# URBAN DESIGN COMMITTEE

2. [Lincoln Central Library-UDR26027](#) – *Advisory Review & Final Action*

APPLICATION NUMBER	Urban Design Record #UDR26027
APPLICATION TYPE	Advisory review
ADDRESS/LOCATION	Lincoln Central Library, 1111 O St.
HEARING DATE	April 07, 2025
ADDITIONAL MEETINGS	-
APPLICANT	Ryan Wieber, <a href="mailto:RWieber@lincoln.ne.gov">RWieber@lincoln.ne.gov</a>
STAFF CONTACT	Arvind Gopalakrishnan, 402-441-6361, <a href="mailto:agopalakrishnan@lincoln.ne.gov">agopalakrishnan@lincoln.ne.gov</a>

**RECOMMENDATION: CONDITIONAL APPROVAL**

**MATERIAL DIAGRAM I** Metal Facade | metal panel profiles makeup

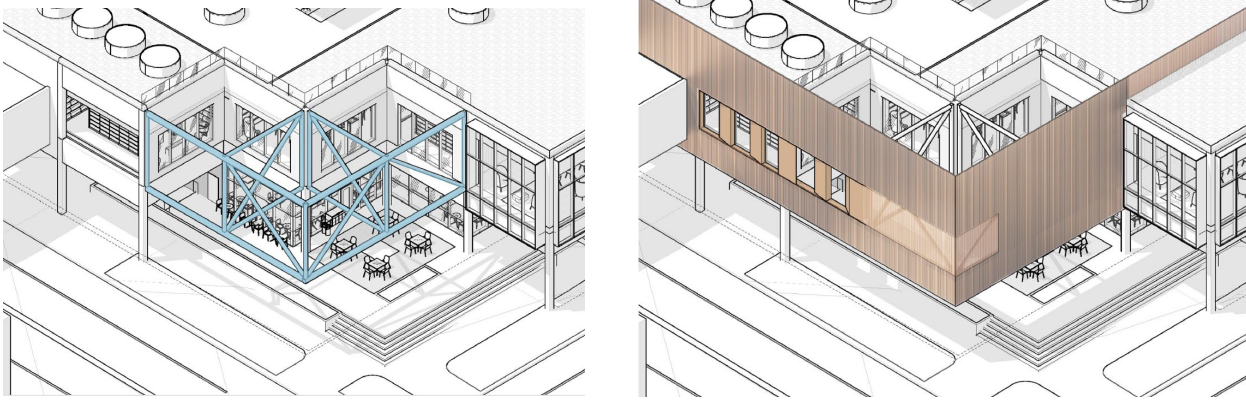
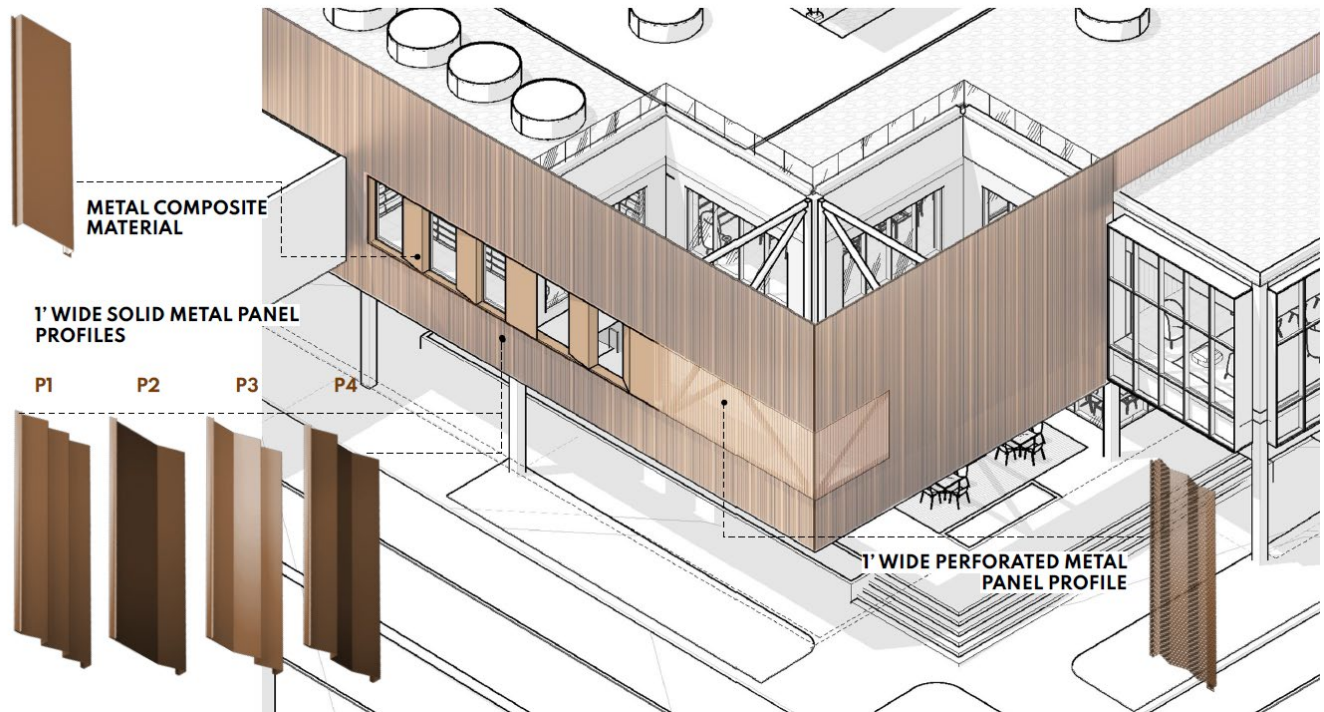
**1.** The design removes the majority of the existing building’s opaque masonry facade infill within the cast-in-place structure to remain and creates a glazed and transparent ground floor of the library. This is a deviation from the Downtown Lincoln Design Standards that currently require durable masonry materials or similar materials as the primary exterior material for the first 20 feet above street level.

**2.** The Library design include glass curtain wall structures less than 20 feet above street level whereas the current Downtown Lincoln Design Standards only allow glass curtain wall structures more than 20 feet above street level.

**Comments from staff:** Given the City’s broader encouragement of increased transparency at the street level, and in recognition of the proposed change of use to a civic library, the staff does not consider the reduction of the brick facade a significant deviation from the intent of the Design Standards. The increased transparency at the pedestrian level is consistent with the goals of an active, inviting downtown streetscape and is supported by staff.

**Comments from staff:** In alignment with updated Downtown Design Standards, staff is prepared to support approval of the curtain wall systems as proposed, provided the glazing meets a minimum Visible Light Transmittance (VLT) of 0.45 and does not employ mirrored or highly reflective glass. These conditions ensure that the curtain wall contributes positively to the pedestrian environment by maintaining visual connectivity between the interior and the public realm.

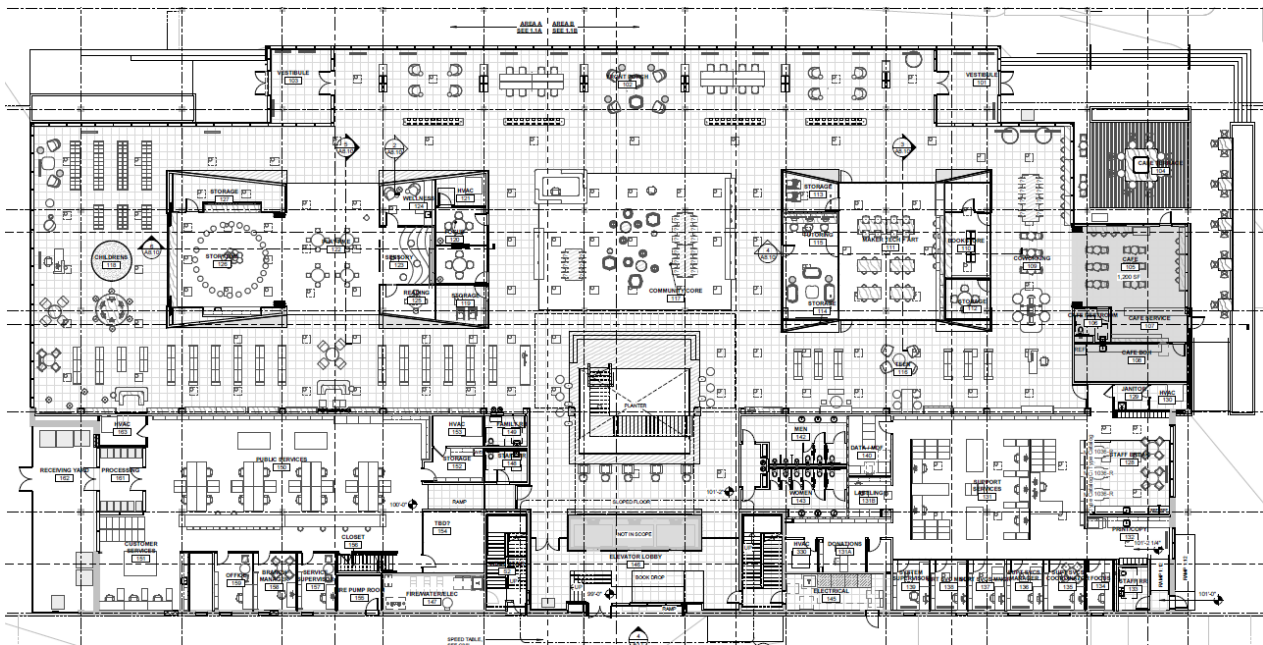
2. **ADA Accessibility at 12th Street and O Street Corner** - The current ADA access configuration at this corner appears constrained, with ramps positioned further south than the main entrance and the curb ramps at the street corner leading directly to a set of stairs, which may create confusion for visitors seeking an accessible route. Staff recognize the spatial limitations of this area but encourage the design team to explore opportunities to incorporate a ramp or tapered steps that are clearly visible and directly accessible from the curb ramp.
